STATE OF ILLINOIS
 DEPARTMENT OF PUBLIC WORKS & BUILDINGS
 DIVISION OF HIGHWAYS

FOR INFORMATION ONLY:
 BRIDGE NO. 7 STRUCTURE 077-0013
 BRIDGE NO. 8 STRUCTURE 077-0014

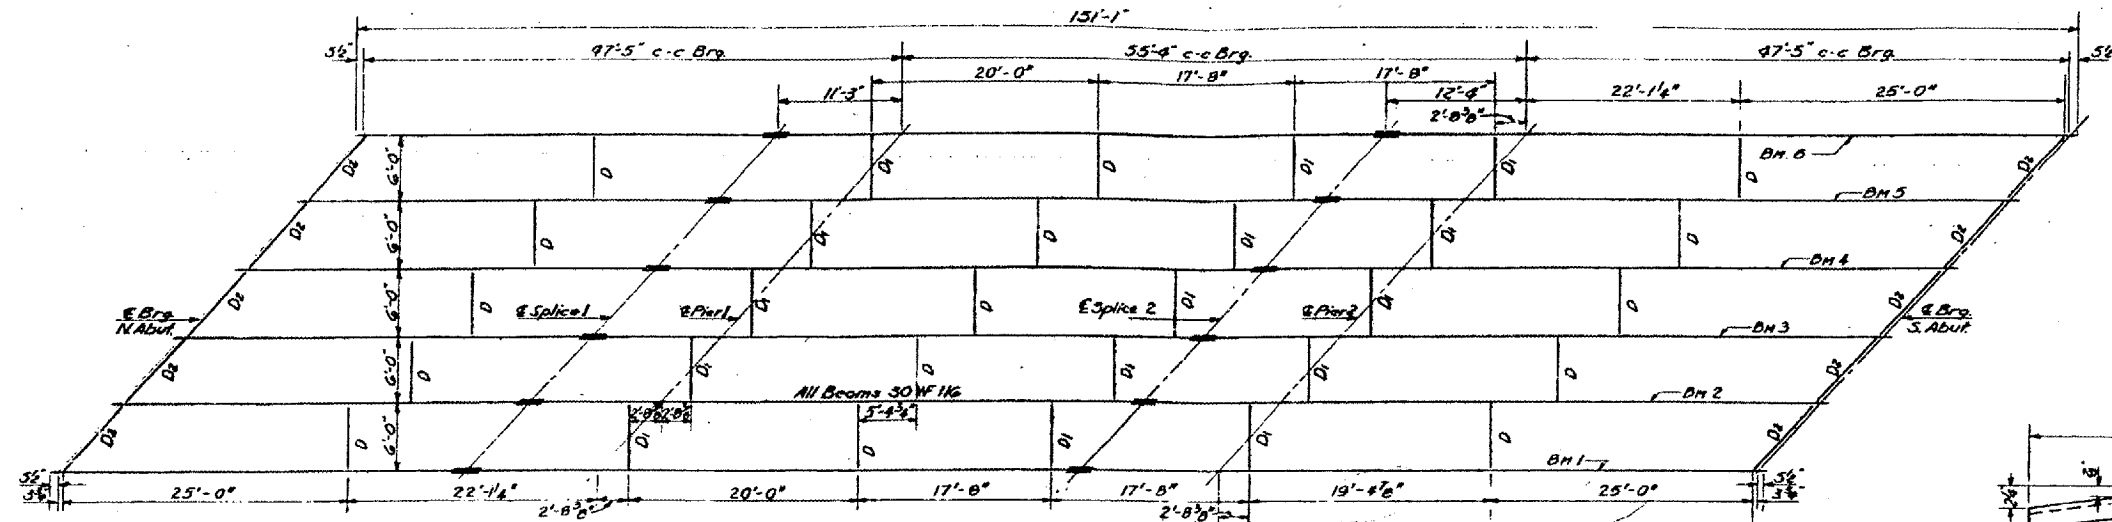
REV 2-14-62 WLP Changed 3/4" AB X 2" CR to 1/2" AB CR Stud Also Add 2" Vent holes to Exp Guard Angles.
